MEMORANDUM

Re: Concept Site Plan for a Proposed New
Draper's Liquor Store – 2615 Centreville Road;
Tax Map 44E, Parcels 1062 & 1063-1

MEMORANDUM

ORGANIZATION: CENTREVILLE MD
Re: **Concept Site Plan** for a Proposed Mixed-
Use Development @ 425 S. Commerce Street,
Centreville MD, Tax Map 44B, Parcel

Figure 16

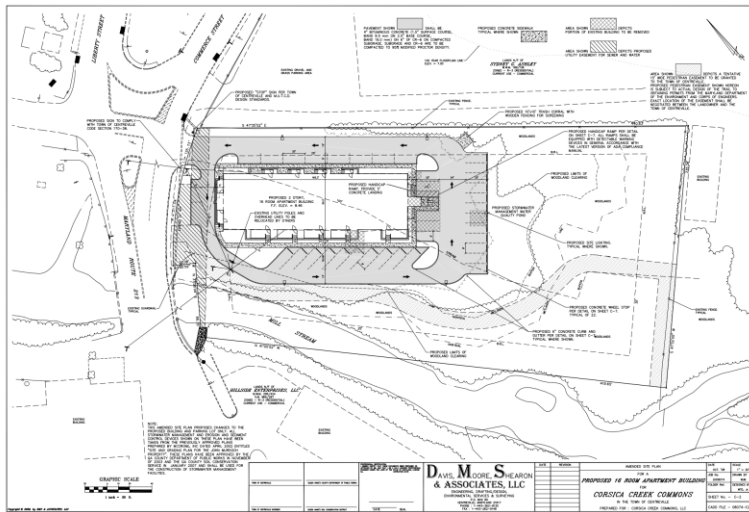
The Millstream trail extension is also included in the Town of Centreville Comprehensive Plan: 2040 Text and Figure 16 on page 76:

Extend the Millstream Trail from Mill Stream Park east into the Growth Area and build an interconnected trail network as shown in Figure 16, “Greenway and Trail Plan”. The Town should require developers to build multi-use trail linkages within and near their development projects using the figure as a guide. This is relevant within the Town and in the Growth Area.

The Amended and approved 10-2008 Site Plan showing trail easement

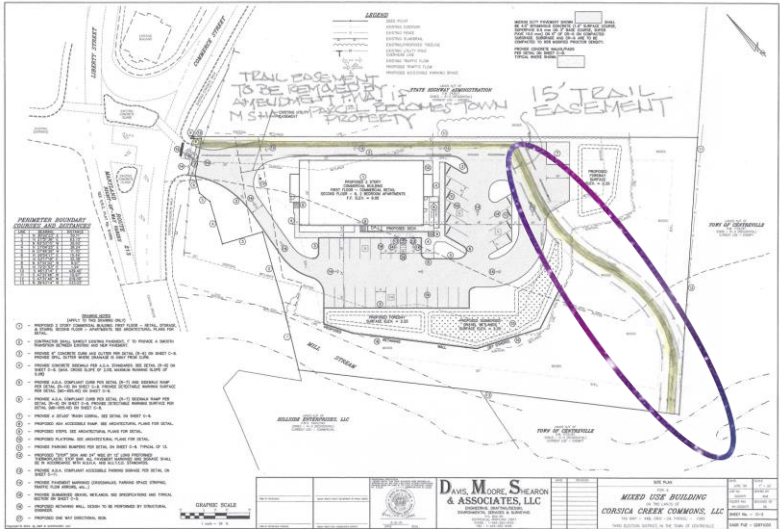
This site was the subject of two Public Works agreements and a rezoning approved by the Town of Centreville. The 2009 PWA establishes a fifteen-foot trail easement, noted in Ordinance 05-2015. Currently, this trail easement is still in effect. The Millstream trail extension is also included in the Town of Centreville’s Greenway and Trail Plan in the Town of Centreville Comprehensive Plan: 2040. TAC has discussed with the applicant and asked that it be shown conceptually to the North portion of the site with a provision that the easement may not be needed if the Town’s acquisition of the adjacent MD SHA/Ashley property through Program Open Space funding is finalized. Images below depict a suggested modified location for the easement and how it is proposed to be incorporated into the site. The east to southeast (far right) side of the easement suggested by Town staff that would connect to the Southeast portion of the property does not appear to be included in the current application.

3.3. Trail Easement. The Owner shall grant to the Town a 15’ wide easement for construction and maintenance of a pedestrian trail. The trail shall run from the conjunction of the Town’s trail and the paved sidewalk in front of the building along the Mill Stream to the rear of the Property and unless otherwise mutually agreed shall conform to the “15’ Wide Pedestrian Easement to be Granted to the Town of Centreville” as shown on Sheet C-2 of the existing site plan.

The conceptual alignment as suggested by staff:

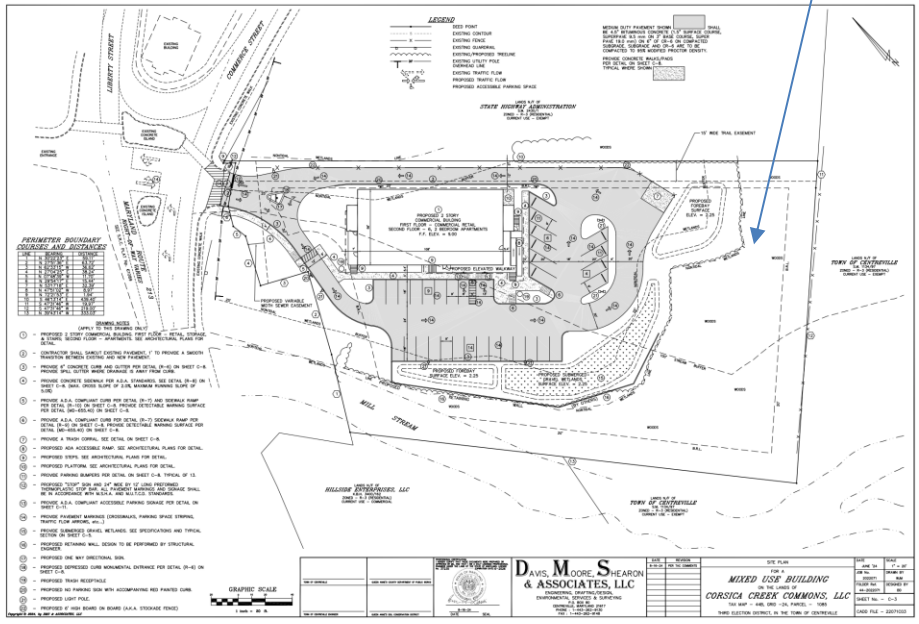
The Planning Commission should have further discussion about the newly suggested alignment and how the current Public Works Agreement that is still in effect should most appropriately get updated to address the relocated easement and the potential for its dissolution is recommended.

Applicant’s Response to TAC comment: “We have revised the travel ways, trash corral, and stormwater to provide the PWA’s 15’ wide trail easement. We note your provided information that this easement may be dissolved if the Town’s acquisition of the neighboring property continues as planned.”

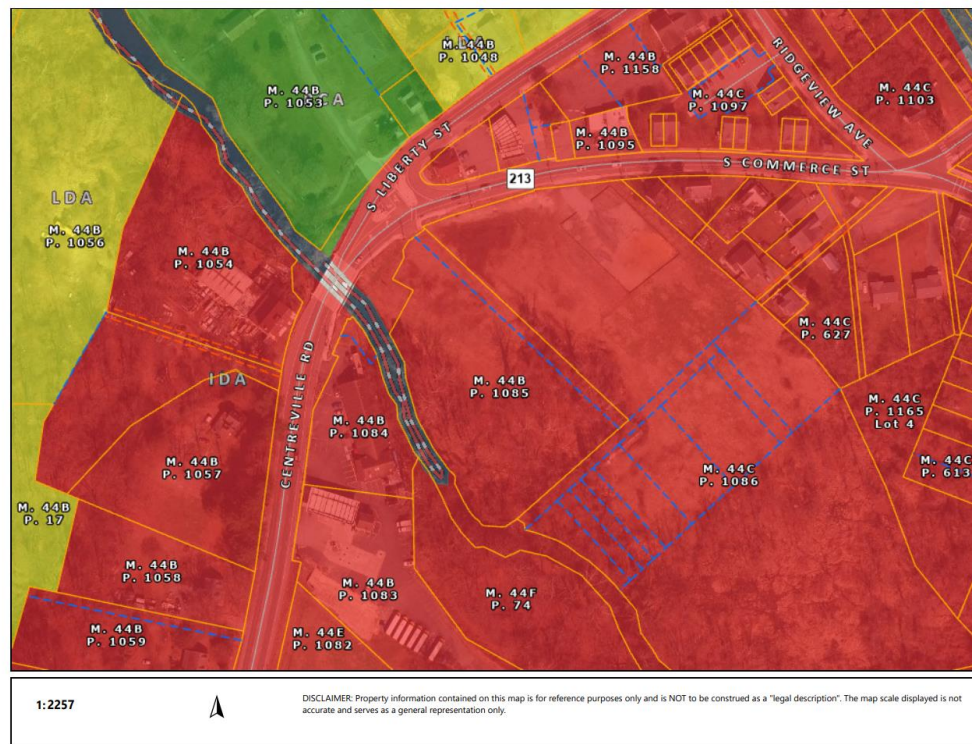
“Since this project involves activity within the 100’ CA Shore Buffer, we should note that the property is in the IDA and is designated as Modified Buffer Area (formerly called Buffer Exempt). The Hillside building and the former “Sleeve Plant” on the subject site formed the rationale for the exemption requested by the Town in 1985.

As you can see from the above this exemption mandatorily places the burden on the Town under the definition to propose measures offsetting the loss of the buffer. TAC should have a discussion on this and address this to the PC and perhaps to the Council. (see attached Centreville CAC Map)”. (snip below)

Critical Area Commission Comment on this subject: The Town must determine if the proposed development meets all the requirements of the Town of Centreville's Critical Area program including the MBA provisions. The Critical Area program staff has also shared Critical Area Commission's Policy documents which many local jurisdictions adopt that identify mitigation buffer yard planting, natural forest vegetation, offsets, and/or establishing a fee in lieu of (when officially established).

"The proposed project results in 10,124 square feet of impervious area within the buffer exempt area 100' to stream. Upon review of the MSHA impervious areas for the bridge replacement project, they had 10,770 square feet of impervious within the buffer exempt area 100' to stream. We feel that mitigation is not required given the proposed is less than that from the MSHA project. We will continue to work with staff on this matter."
